DEVELOPMENT APPLICATION ASSESSMENT REPORT

Application Number:	DA2022/1252
----------------------------	-------------

Responsible Officer:	Adam Croft
Land to be developed (Address):	Lot 32 DP 7090, 20 The Esplanade NARRABEEN NSW 2101
Proposed Development:	Construction of a dwelling house including swimming pool
Zoning:	Warringah LEP2011 - Land zoned R2 Low Density Residential
Development Permissible:	Yes
Existing Use Rights:	No
Consent Authority:	Northern Beaches Council
Land and Environment Court Action:	No
Owner:	Jason Smith Emily Smith
Applicant:	Nilesh Munot

Plan 1. Eastern Elevation.

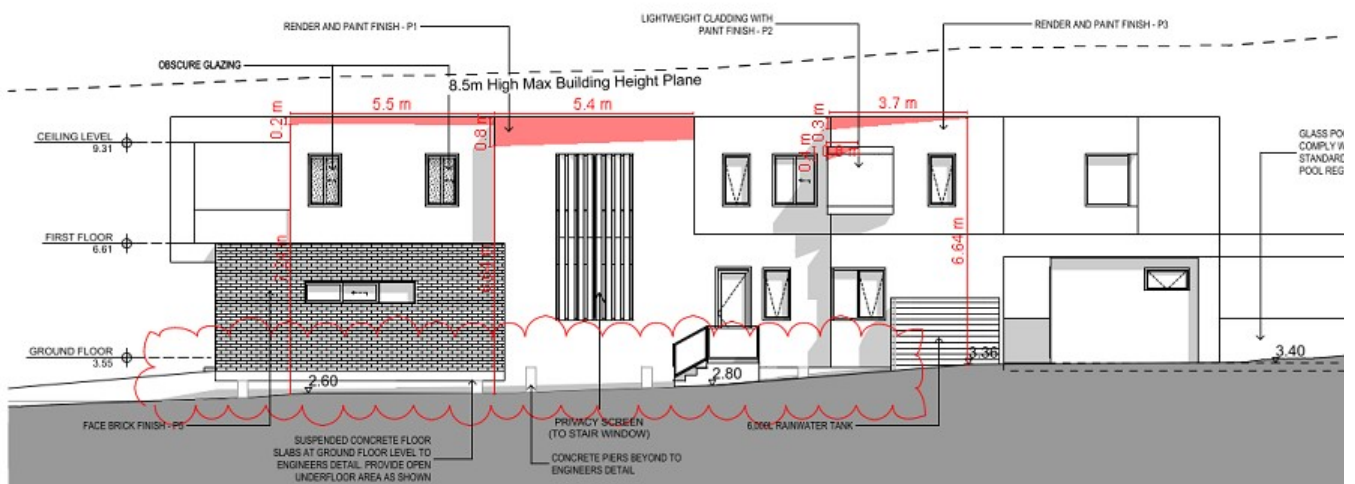
The proposal includes various breaches of the building envelope control at the eastern and western elevations, as depicted on the below plans.

The subject site is flood affected and the levels of the development are prescribed by the relevant flood planning controls. As such, the proposal is unable to step with the topography of the site and this contributes to the building envelope breaches, particularly at the front of the dwelling. Despite this, the proposed dwelling design is considered to respond appropriately to the topography and site conditions and minimises impacts to adjoining properties.
